Tesla, Inc. Service Bulletin		<h2>Remove Front Door Outer Belt Seal Stuffers</h2>	
SB-19-11-006 December 2, 2019			
Classification		Section/Group	Mobile Service
Repair Bulletin		11 - Closures	Can Perform (where permitted)
Model Year	Model	Country/Region	Version
2016 - 2018	Model X	All	All
<small>The model(s) and model year(s) listed are a general approximation of the affected VIN list. Refer to the VIN/Bulletin Tracker or Customer/Vehicle profile to determine applicability of this bulletin for a particular vehicle.</small>

Figure 2

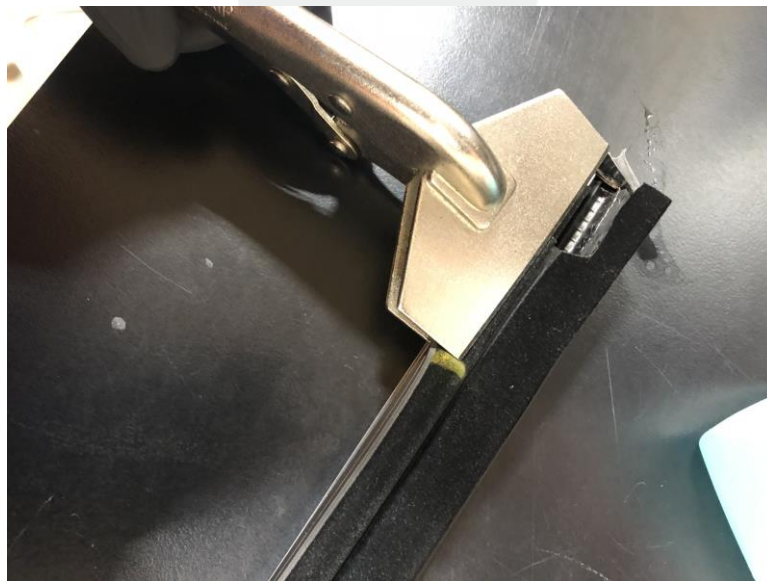
3. Carefully clamp the front end (Figure 1) of the outer belt seal so that an airtight seal is formed (Figure 2).

CAUTION: Do not clamp the stuffer; clamp only the rubber seal.
